PROJECT 1801 FRONTAGE ROAD LIVING GREEN TRAIL PROJECT

ADDENDUM NO. 3

Frontage Road Trail Pre-Bid Q & A- 10-24-2023

DWG. NO.
C-34

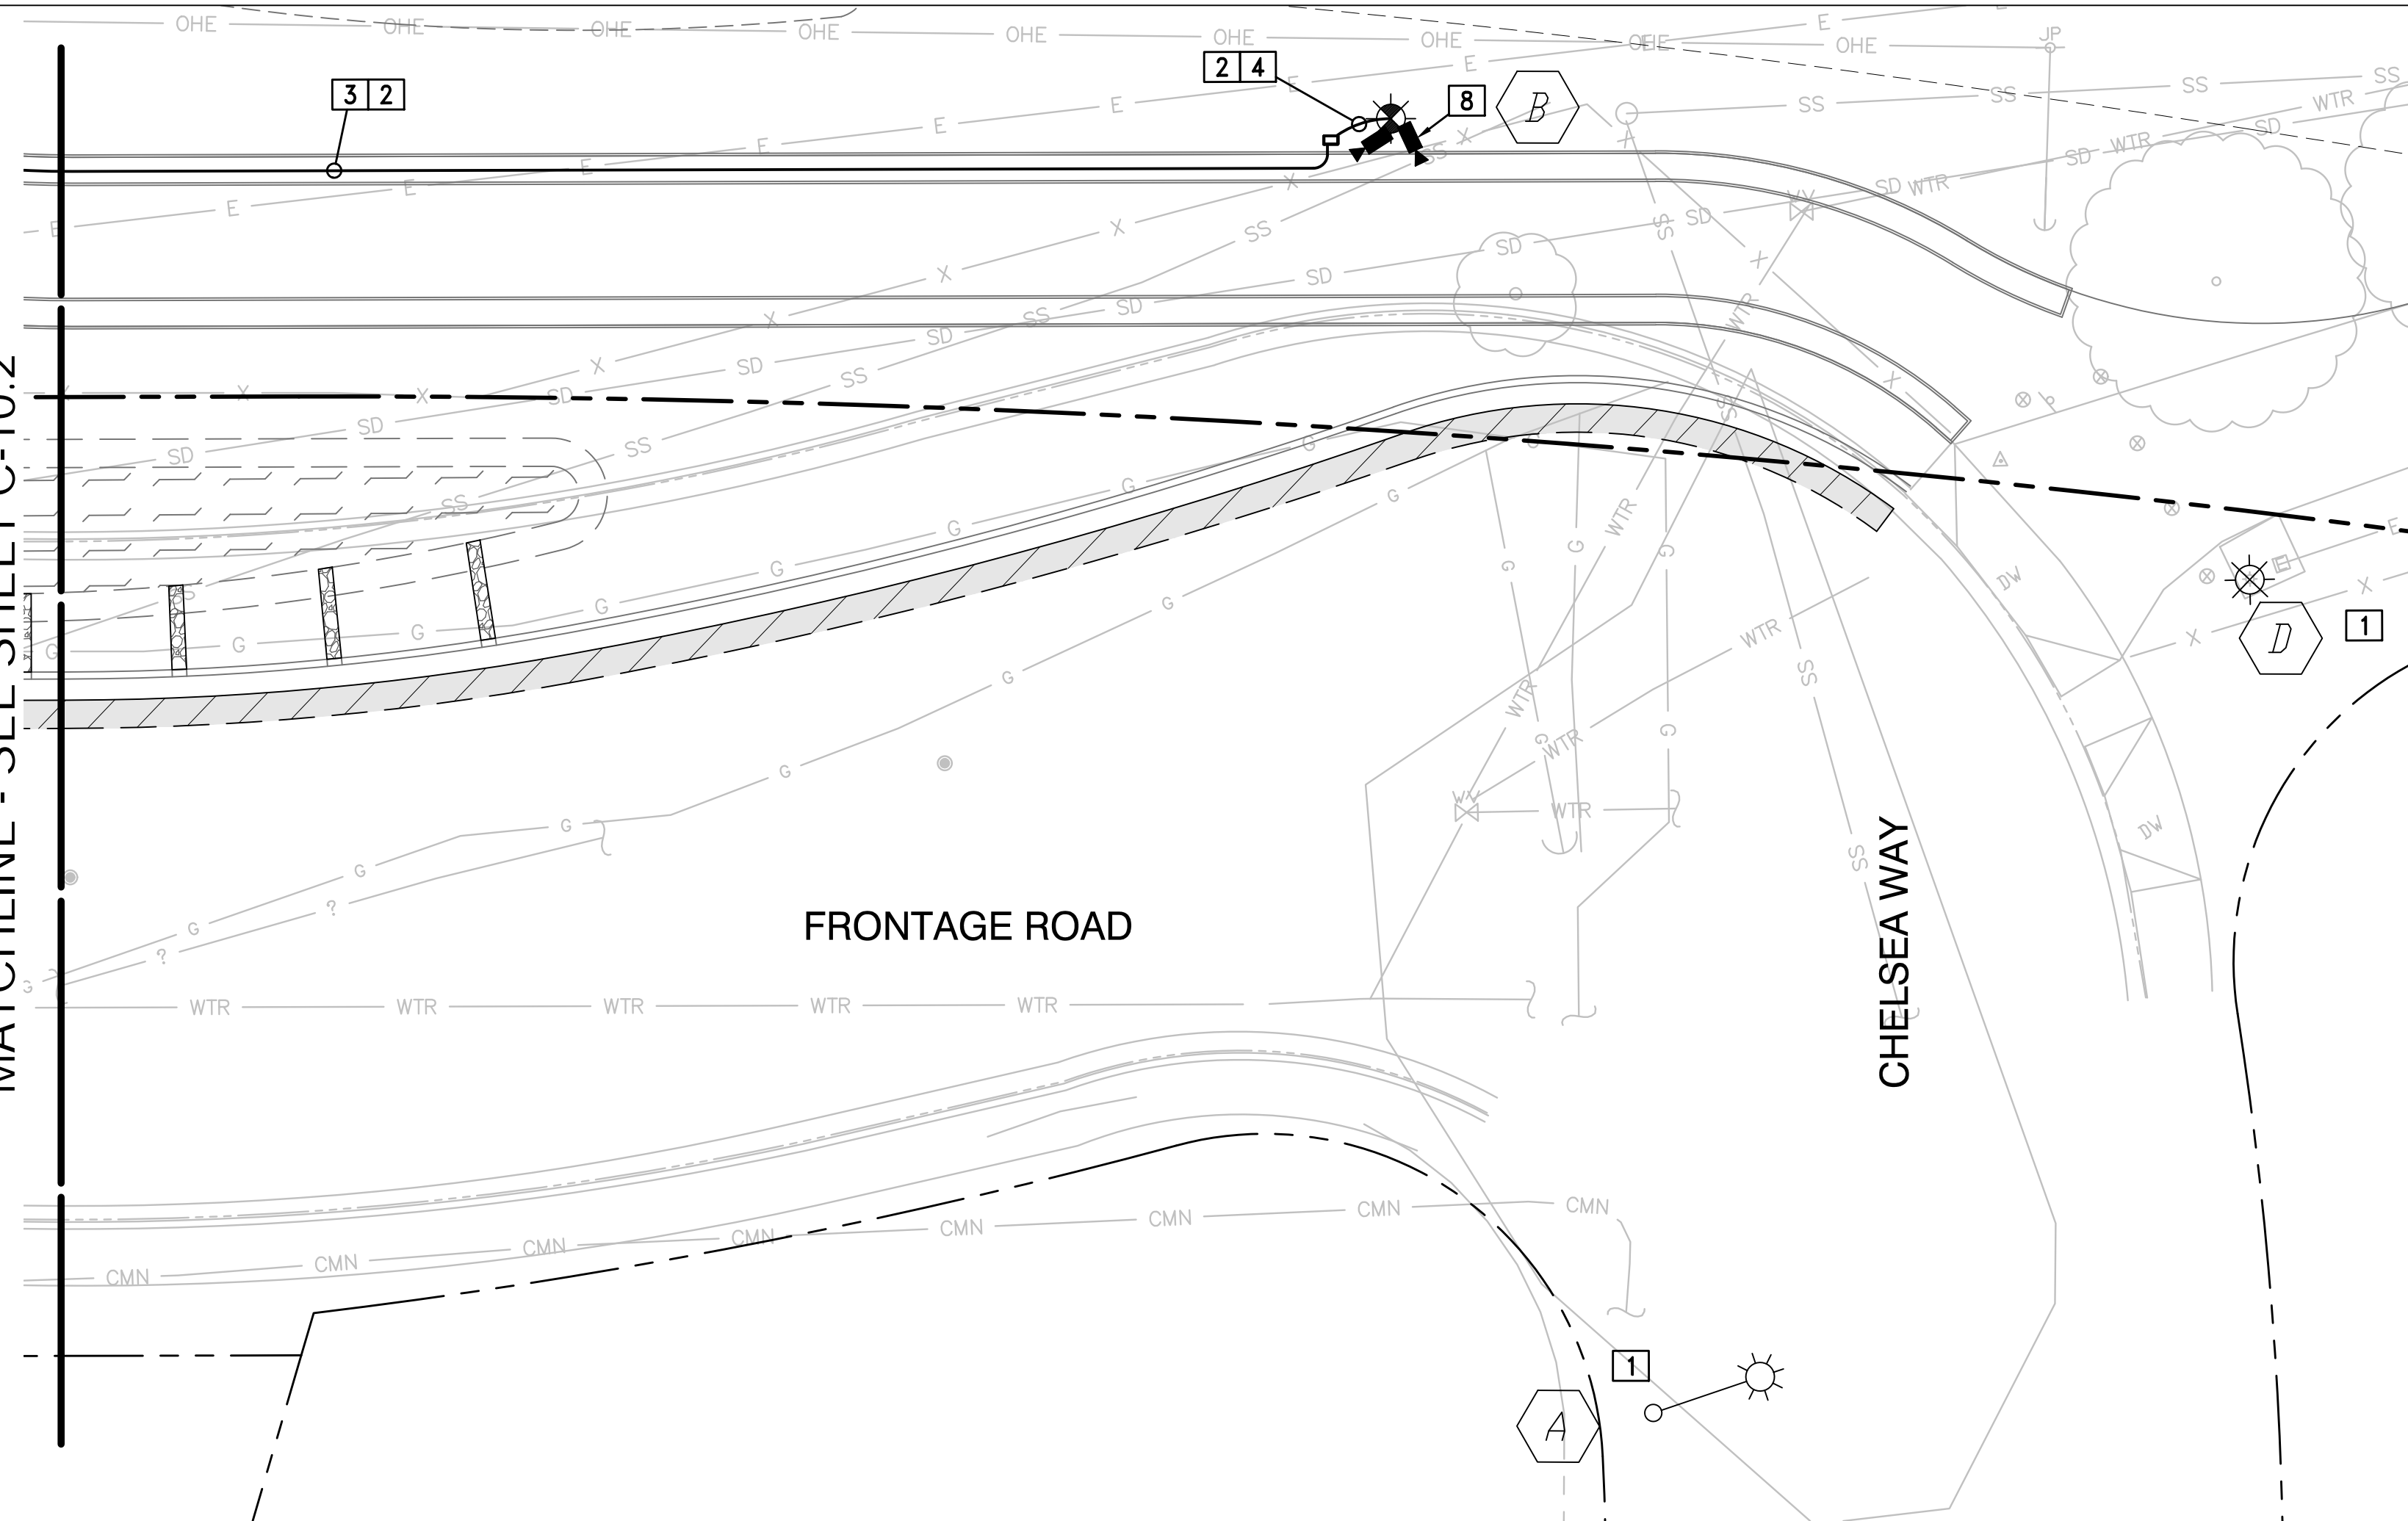
- a. Please be advised of the following clarifications to the contract documents:
 - i. **Concrete Pedestrian Sidewalk Pavement shall be removed and replaced with Asphalt Concrete Pavement with 2 foot decomposed granite shoulders as reflected on the main trail segment. See attached Horizontal Control Plan.**

16. Q: Please clarify horizontal control and layout (line/curve tables, station and offsets) for the project.

A: Refer to the attached horizontal control plan sheets C-3.1 – C-3.4.

DWG. NO.
C-11.3

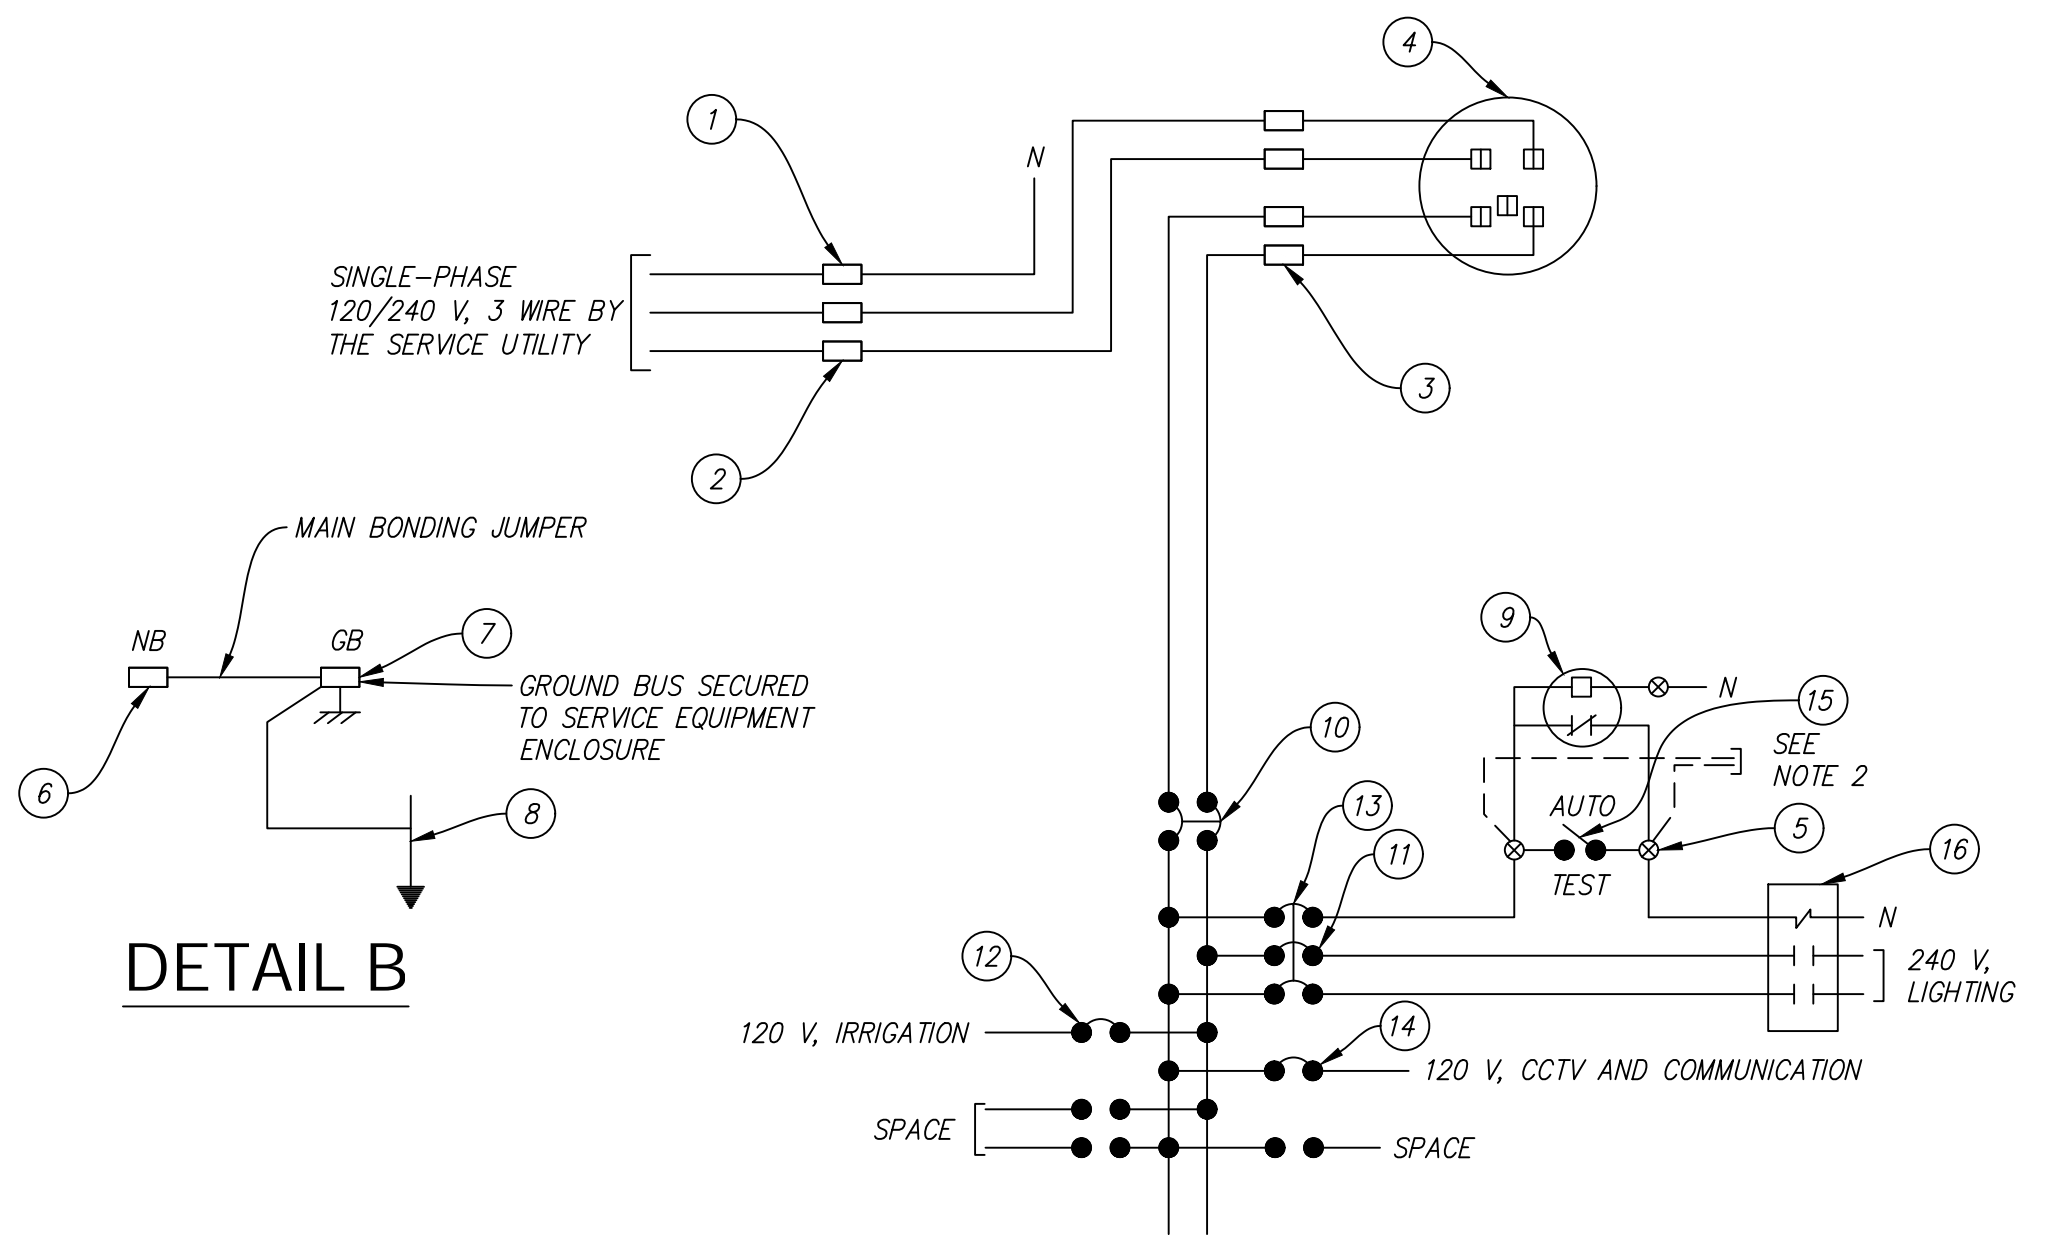
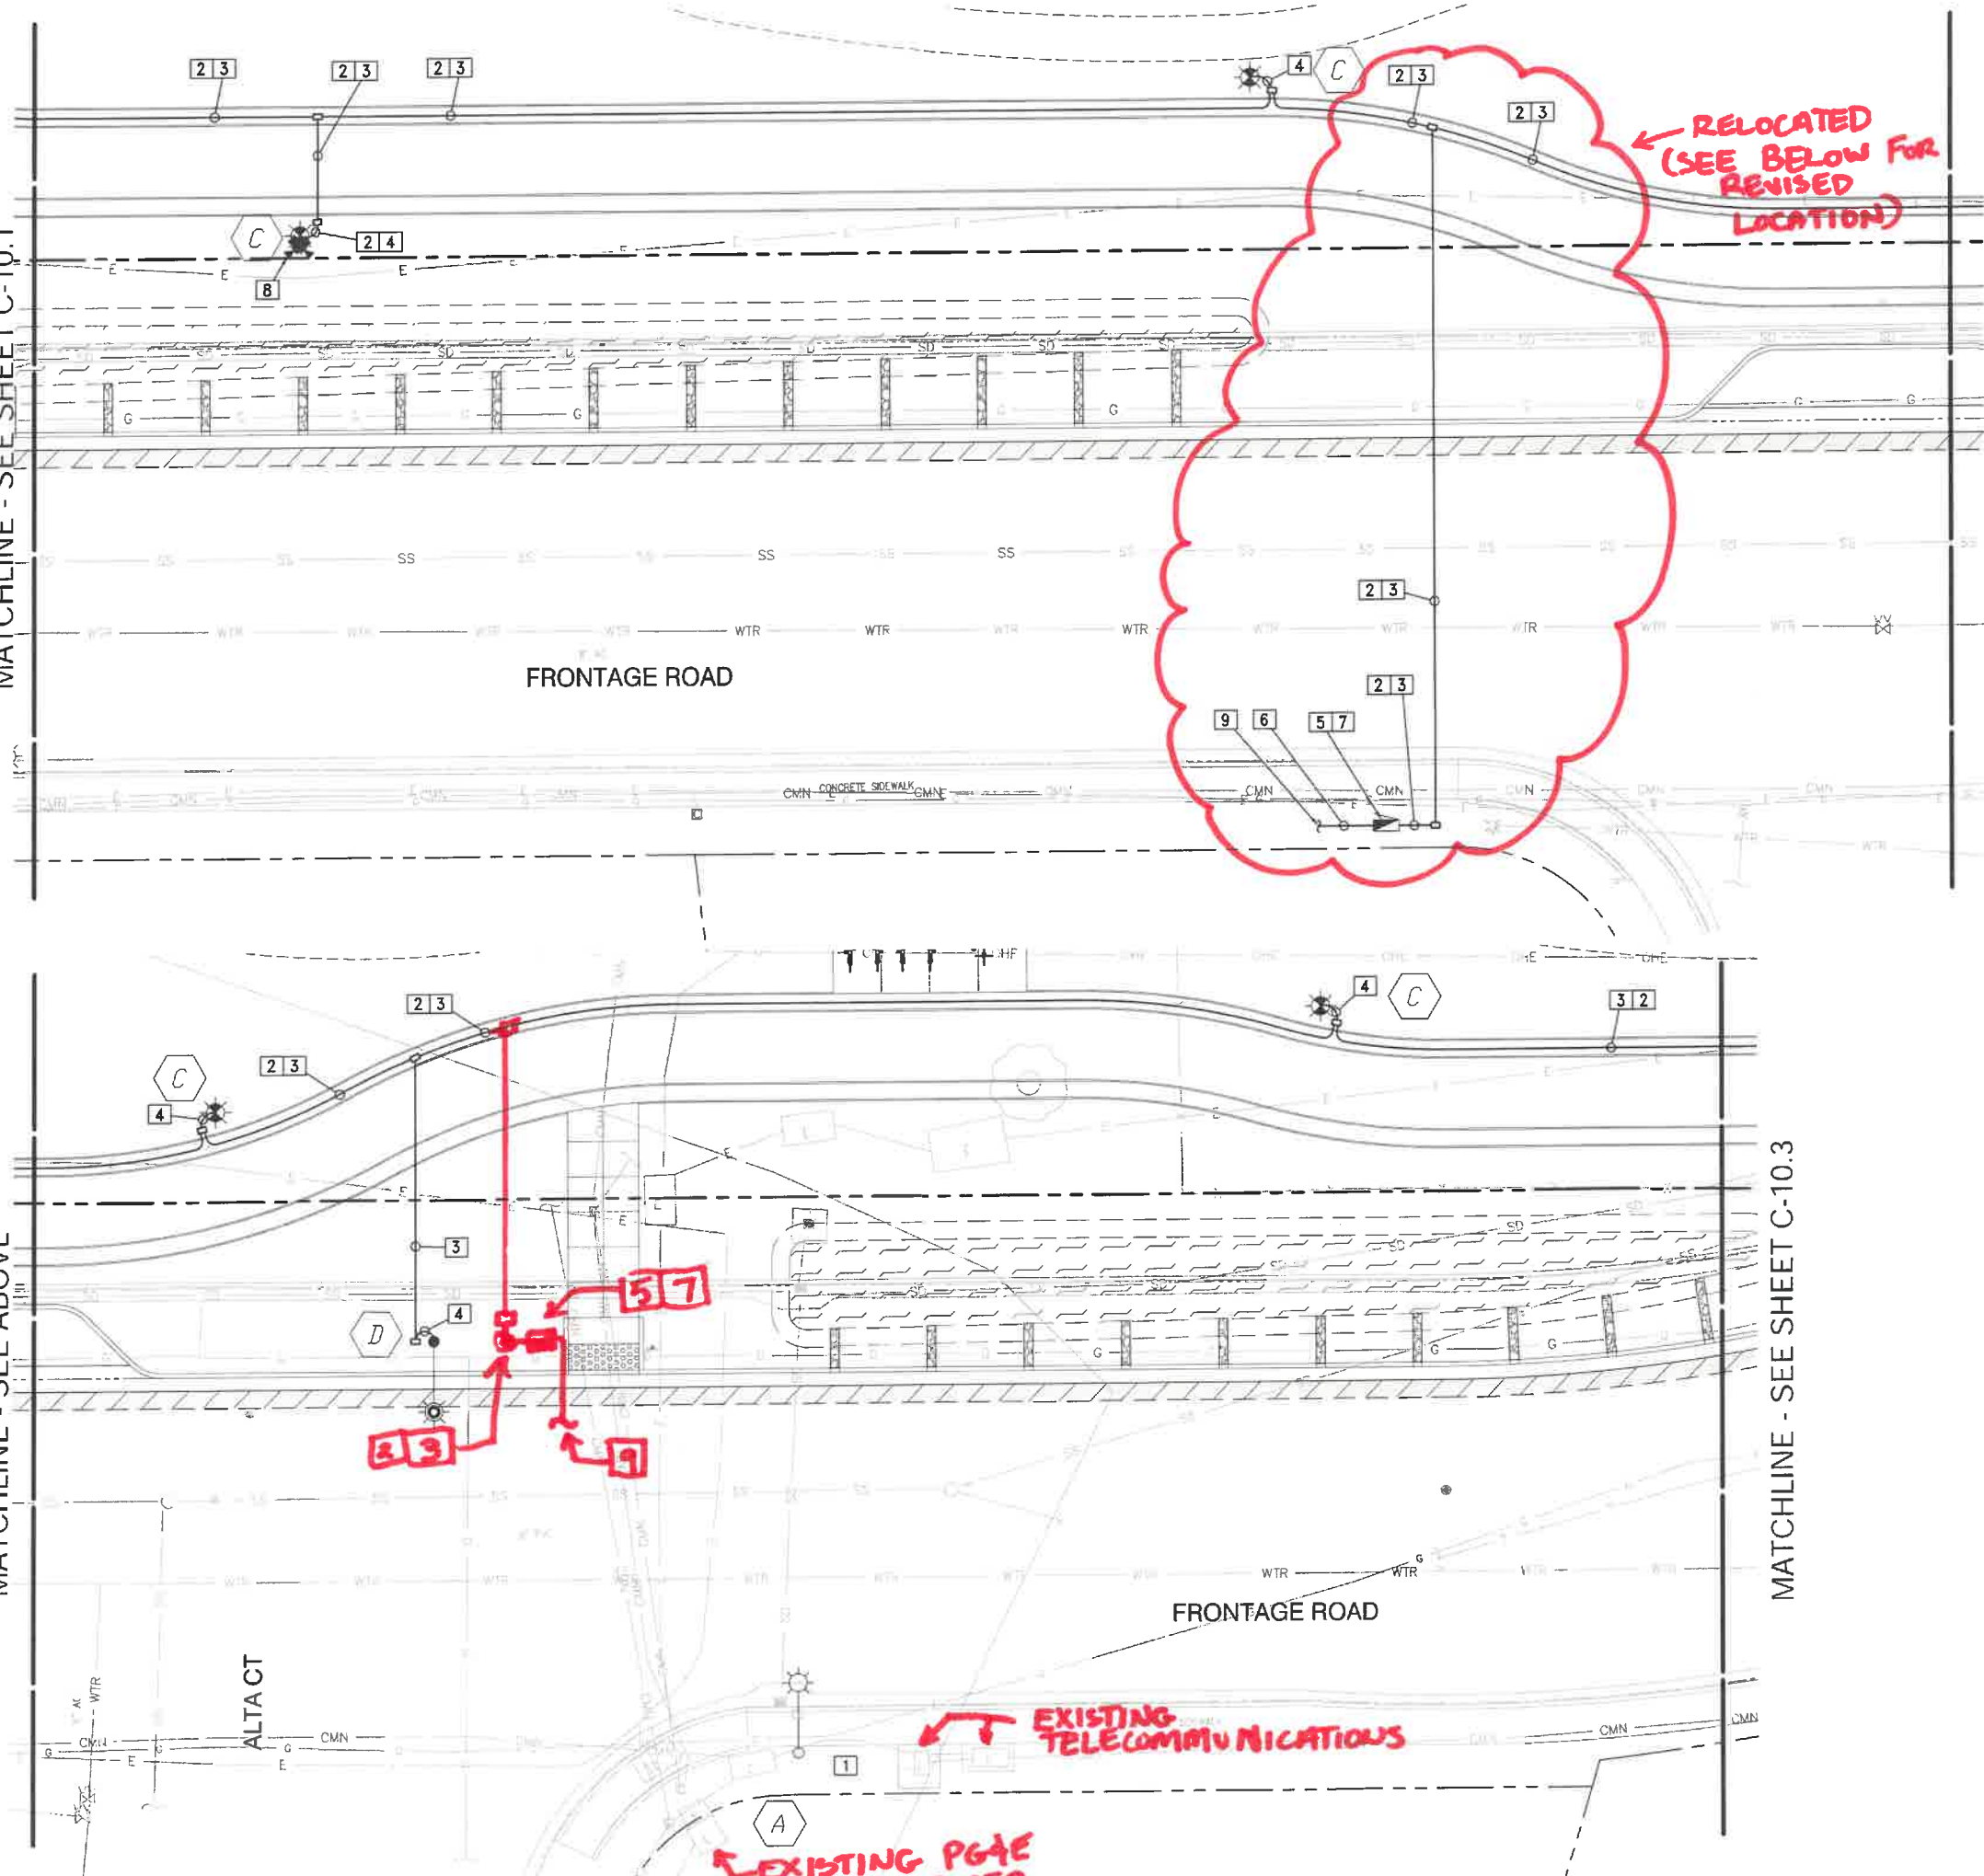
A: Refer to attached C-11.3 sheet. The matchlines in the 11 series currently show C-10.0X series. These shall be corrected and referenced as C-11.X series.

15. Q: Could you please review the plans that were released? It appears the lighting plan sheet C—11.3 is missing.

- a. Sheet C-11.2, note 5 refers to sheet E-4 for reference, and I do not have a sheet E-4. Can the wiring diagram for the service pedestal be provided. We need to know the size of the service pedestal and the size of each individual circuit.

A: See attached sheet C-11.3.

A: See attached sheet C-11.3 for wiring diagram.
